TÜRK LOYDU RULE CHANGE SUMMARY

TL NUMBER: 04/2022

JUNE 2022

RULE CHANGE SUMMARY

Figure 3.7a Sampling position of Charpy V-notch impact test specimens (Base metal)

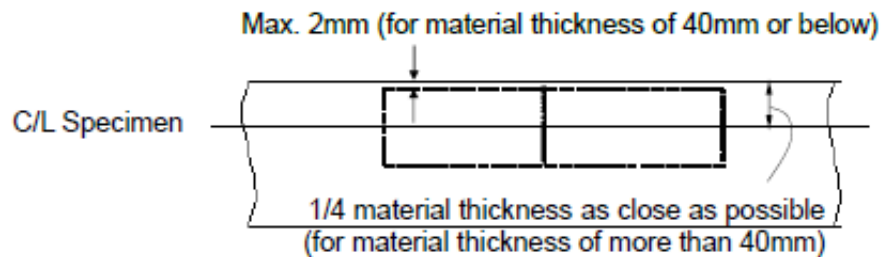
~~For base metal, the largest size Charpy V-notch impact test specimens possible for the material thickness shall be machined, with the specimens located as near as practicable to a point midway between the surface and the centre of the thickness and the length of the notch perpendicular to the surface, as shown in Figure 3.7a. In the case where the material thickness is 40mm or below, the Charpy V-notch impact test specimens shall be cut with their edge within 2mm from the "as rolled" surface with their longitudinal axes either parallel or transverse to the final direction of rolling of the material.~~

Figure 3.7b Sampling position of Charpy V-notch impact test specimens (Weld)

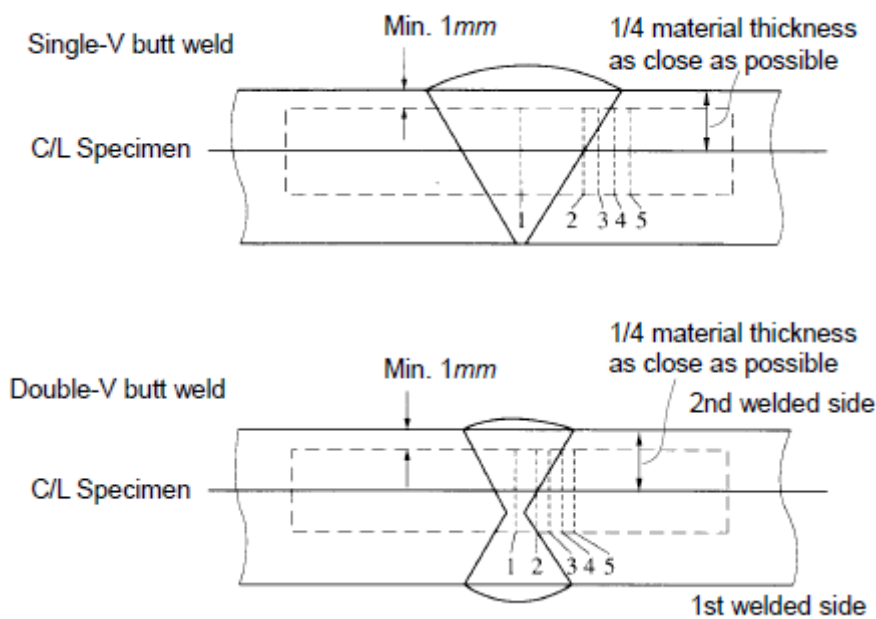
~~For a weld specimen, the largest size Charpy V-notch impact test specimens possible for the material thickness shall be machined, with the specimens located as near as practicable to a point midway between the surface and the centre of the thickness. In all cases, the distance from the surface of material to the edge of the specimen shall be approximately 1mm or greater. In addition, for double V butt welds, specimens shall be machined closer to the surface of the second welded side. The specimens shall be taken generally at each of the following locations, as shown in Figure 3.7b, on the centreline of the welds, the fusion line and 1 mm, 3 mm and 5 mm from the fusion line.~~

Notch location

1 Centreline of the weld

2 Fusion line

3 In HAZ, 1mm from fusion line

4 In HAZ, 3mm from fusion line

5 In HAZ, 5mm from fusion line

Figure 12.38 Sampling position of Charpy V-notch impact test specimens (Weld)

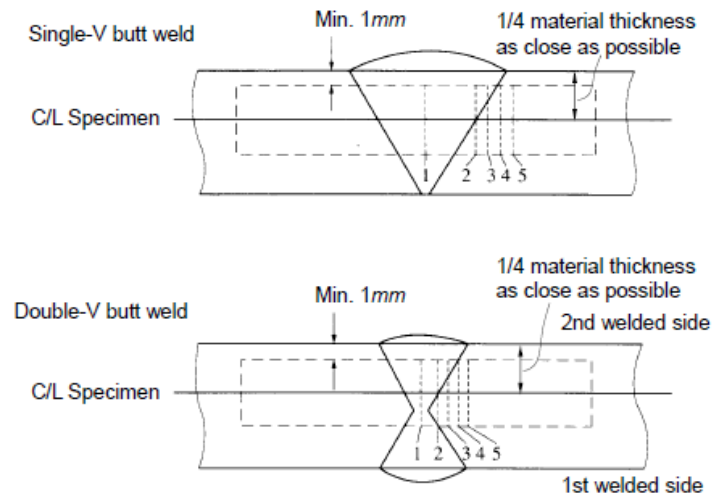
Item J was revised according to UR W1 Rev.4 as below:
